1015 TWEDDLE ROAD DEVELOPMENT
SPA APPLICATION

OTTAWA | ONTARIO

MAY 30TH 2025 | 13383

1015 Tweddle Road
Response to UDRP Comments

3 UDRP

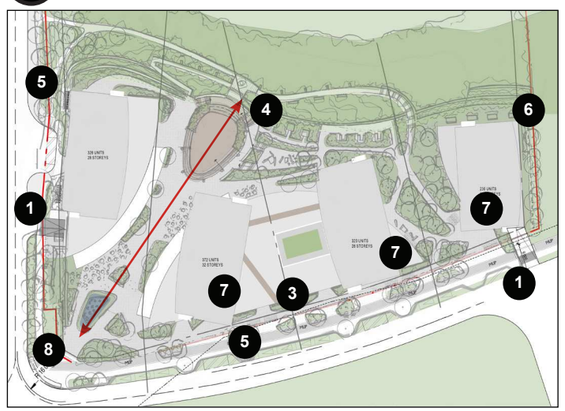
IMPROVEMENTS #2 :

1. Parking garage entrances are relocated and aligned with Trim Road

2. Distance between towers has increased from 23m to 25m.

3. The podium is shifted closer to Jeanne-D'arc Boulevard and forms a continuous edge along the street.

4. A pedestrian-friendly slope was added to integrate the underground parking with the natural landscape.

5. The drop off zone on the west side of Tower B1 has been relocated further north. Additionally, 3 drop-off areas were added on Jean D'Arc Boulevard serving each tower, 2 of which can also serve as loading zones.

6. The basement outline on the east side was adjusted to provide a 3m setback for tree conservation on the eastern adjacent site.

7. Towers B1, B2, and B3 have been repositioned closer to Jeanne D'Arc Boulevard.

8. Keep line of sight clear from Trim Road and Jean D'Arc

4 SPA

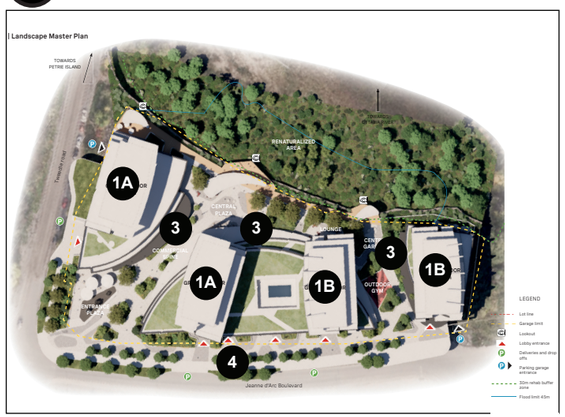
IMPROVEMENTS #3 :

1. The towers have been grouped into pairs, with B1 and B2 parallel to each other, and B3 and B4 also parallel.

2. The architectural envelope expression has been revised to reflect these pairings

3. Canopies have been added along the building's perimeter to help mitigate wind conditions.

4. Frontage along Jeanne D'Arc has been revised to incorporate an urbanized and regularized streetscape along Jeanne d'Arc Boulevard.

SECTIONS | TOPOGRAPHY - B3

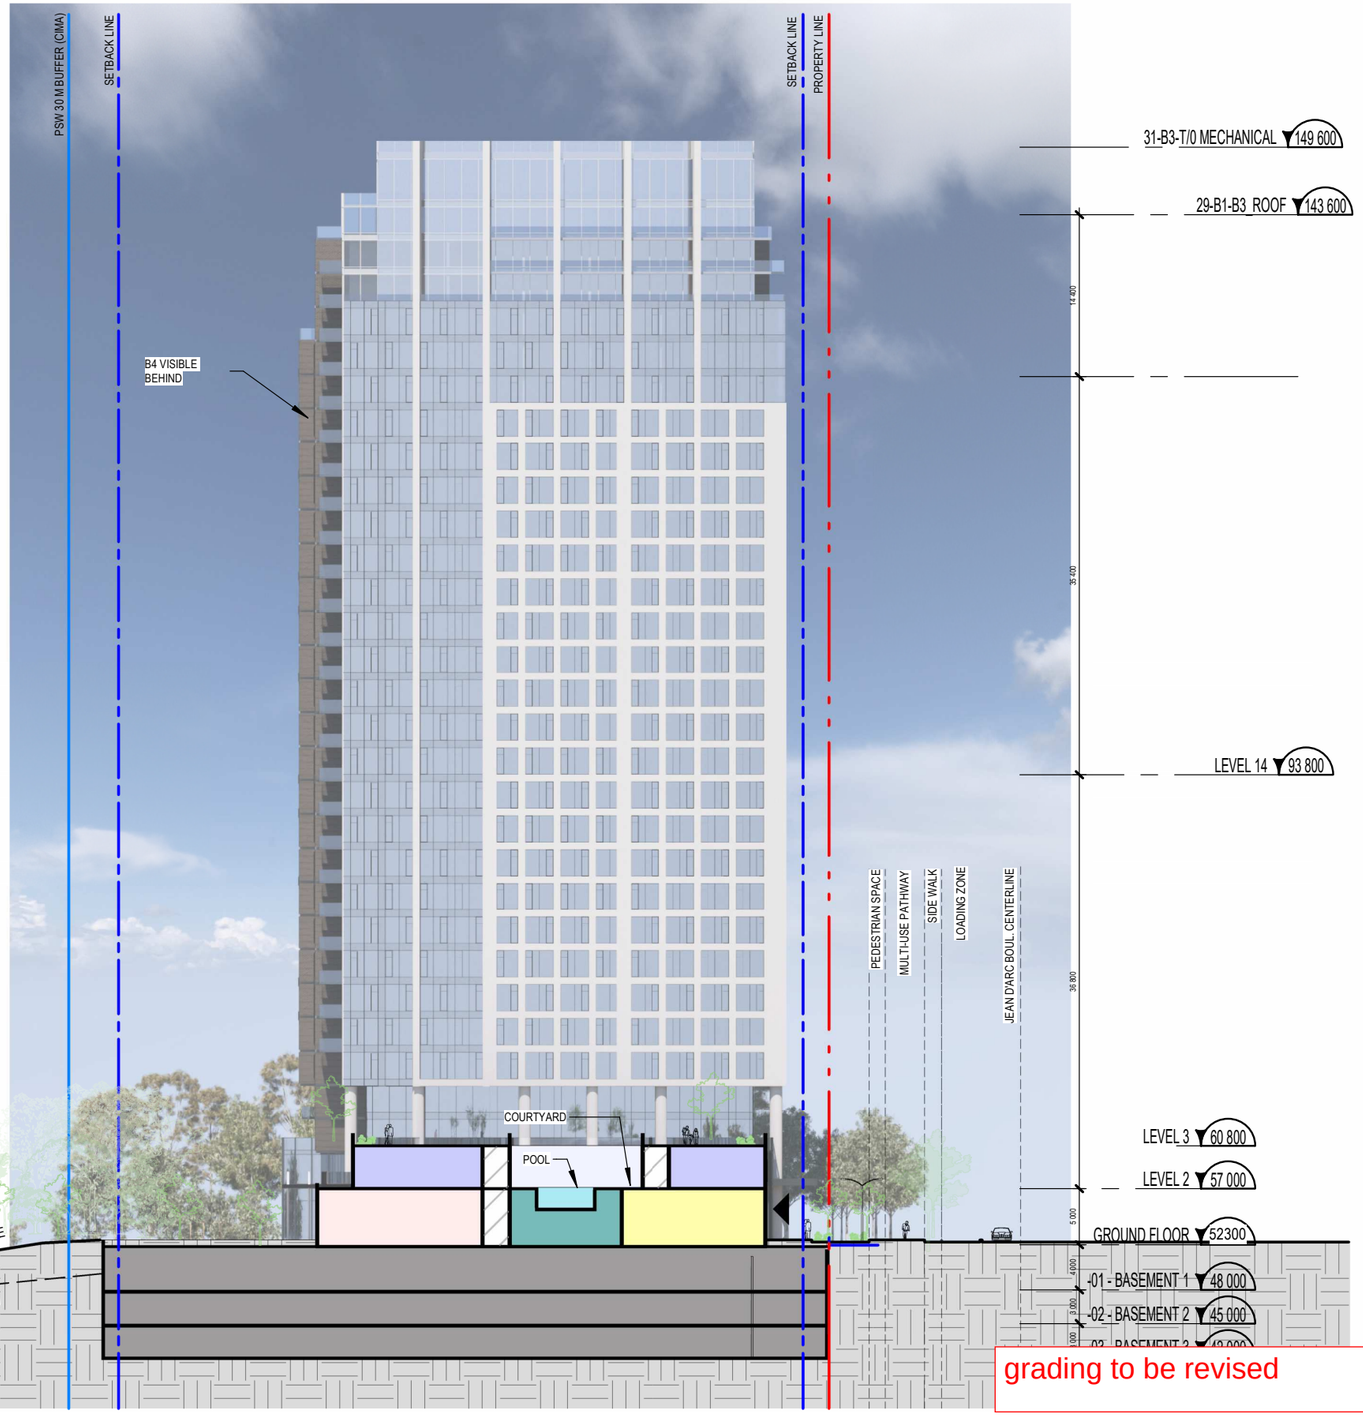
grading to be revised

SECTIONS | TOPOGRAPHY - B4

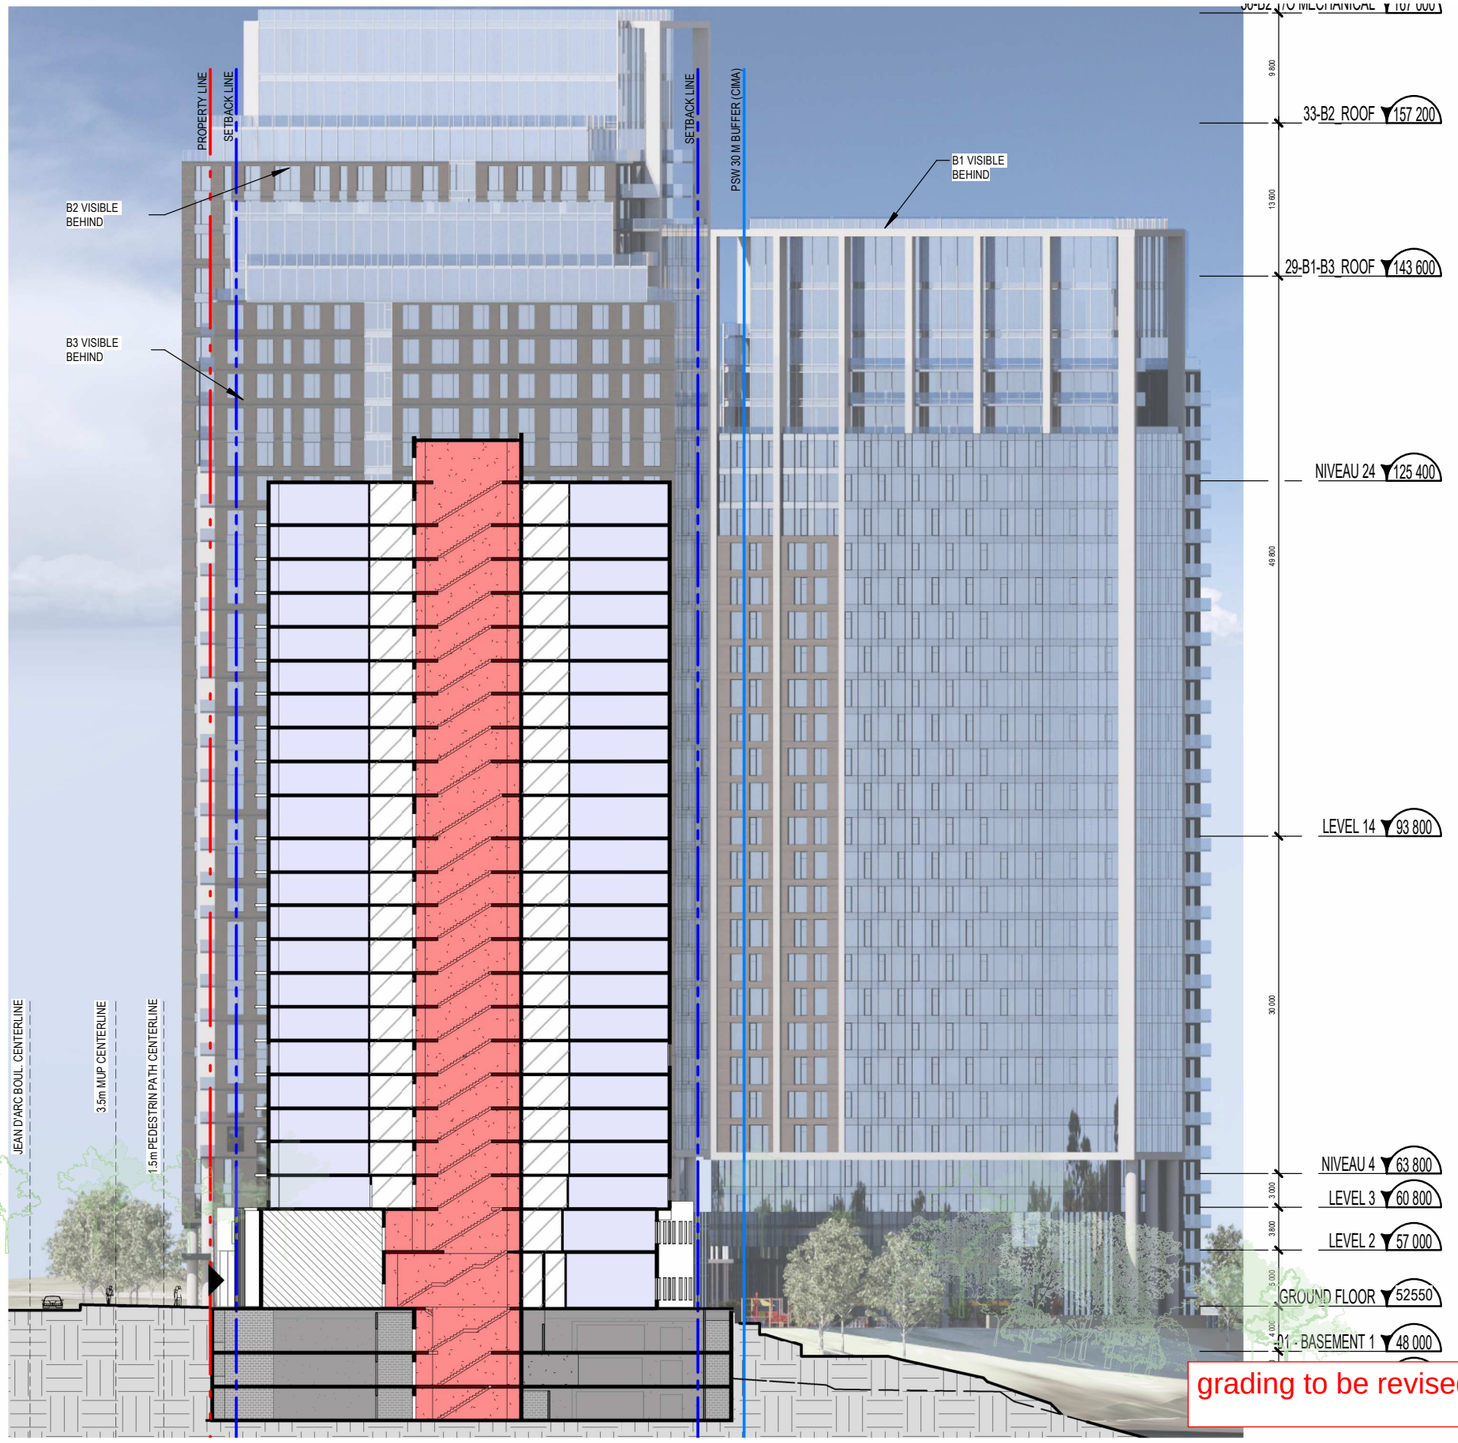
grading to be revised
